# Access Compliance Report

## Public Rights-of-Way

### (Curb Ramps)

Intersection ID: 27355	Main Street: JOHNSTON_RD	Cross Street: BRIXHAM_HILL_AV	Location: SE
ADA ID: 75F795BB13AD	Ramp Type: BlendTrans2	Initial Pass/Fail: Fail	Overall Compliance: No
Severity Score: 8.75			
Codes/Mitigation Info/Possible Solution		Field Measurements/Component Compliance

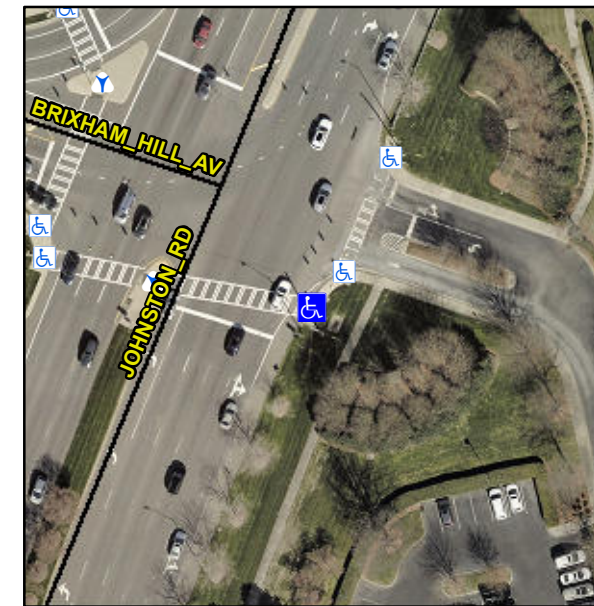
**Not Found, R304.5.1**

**Remove & Replace Curb Ramp With Two New Directional Ramps or Equivalent.**
